Planning (Whitlam FUA Uplift) Minor Plan Amendment 2025

Notifiable instrument NI2025-542

MINOR PLAN AMENDMENT TO THE TERRITORY PLAN 2025–11 Whitlam FUA uplift

MA2025-11 proposes to:

Whitlam – updated Territory Plan map

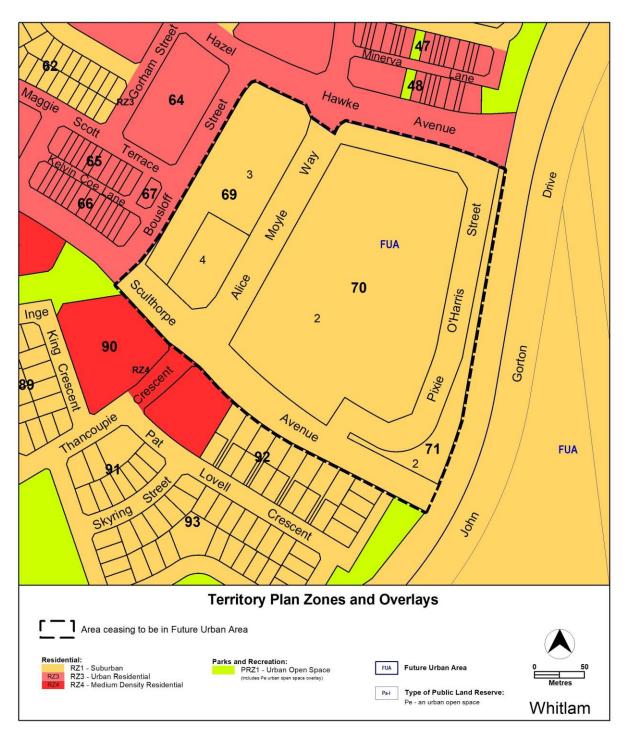
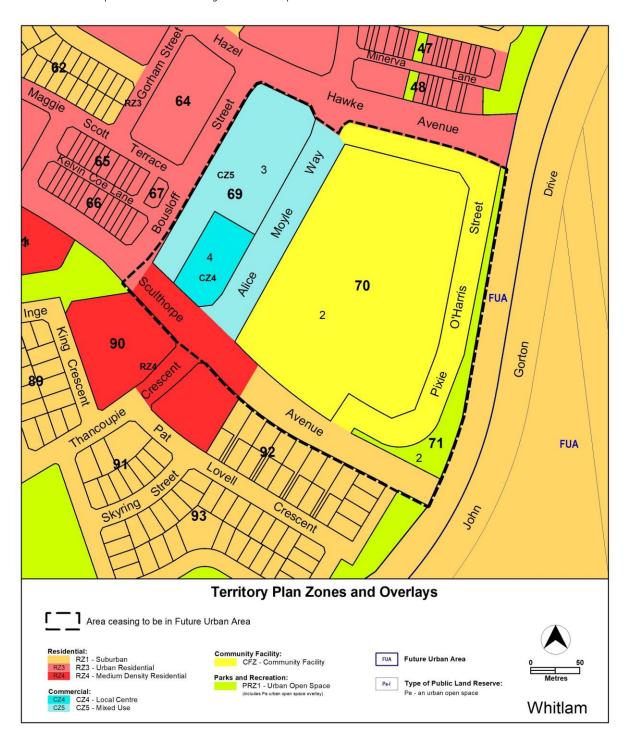
The Territory Plan map is varied to identify the zones and overlays that apply to land ceasing to be in a future urban area.

Proposed new Figure 21A:

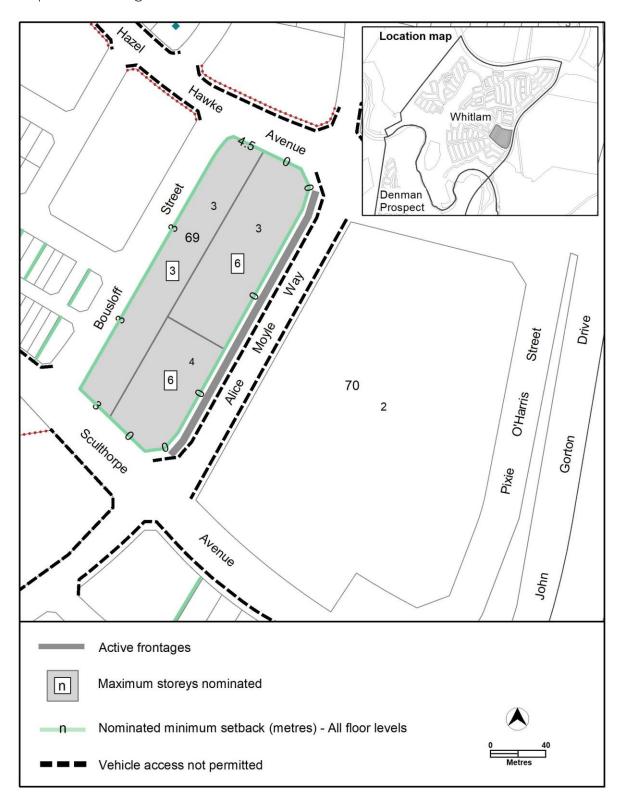
70A. Active frontages are provided in accordance with Figure 21A.

70B. The maximum number of storeys is nominated in Figure 21A.

70C. No vehicle access is provided from frontages as indicated in Figure

70D. For blocks identified in Figure 21A the minimum boundary setbacks to all floor levels are nominated.

1. Territory Plan map

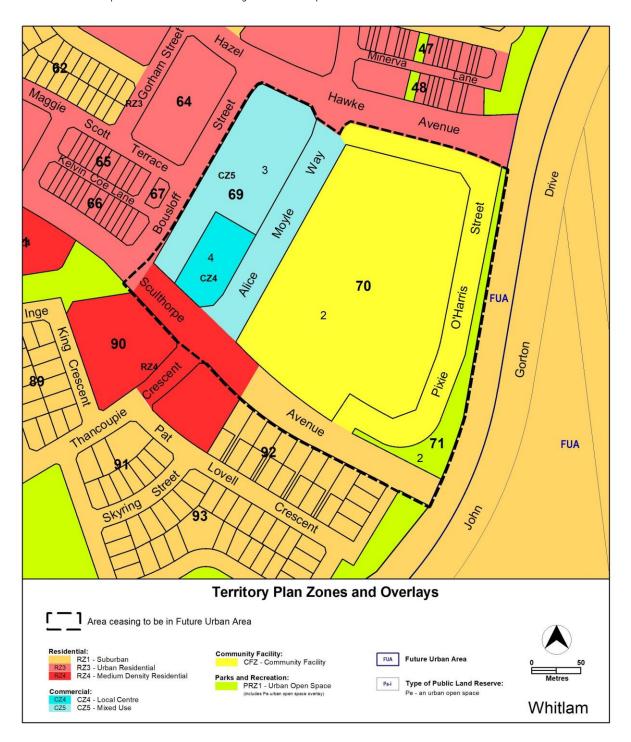
The relevant part of the Territory Plan map is varied as indicated below.

Figure 21A Whitlam – Ongoing Provisions

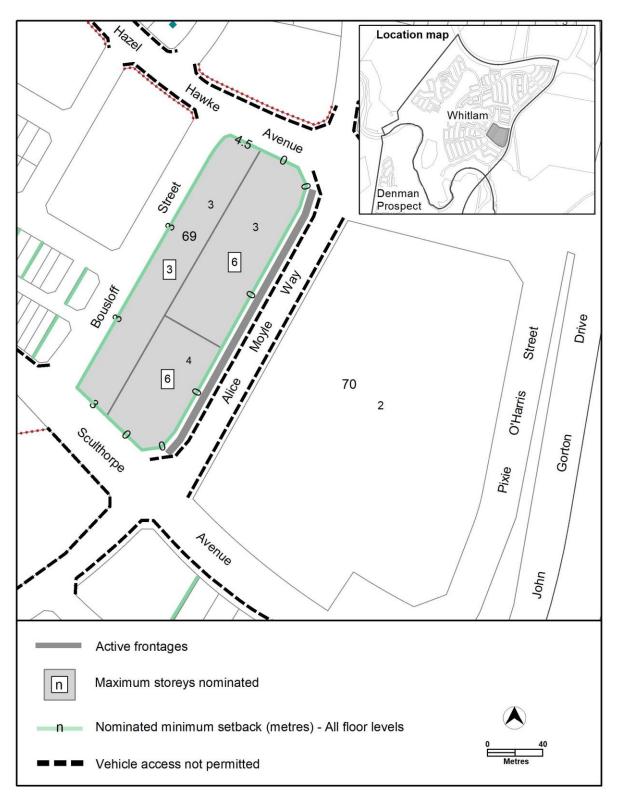
70A. Active frontages are provided in accordance with Figure 21A.

Building height	70B. The maximum number of storeys is nominated in Figure 21A.
Vehicle access	70C. No vehicle access is provided from frontages as indicated in Figure 21A.
Setbacks	70D. For blocks identified in Figure 21A the minimum boundary setbacks to all floor levels are nominated.
	Facades on the nominated frontage with the minimum boundary setback must be articulated with elements such as awnings, balconies, emphasised entrances, verandahs, colonnades and the like.
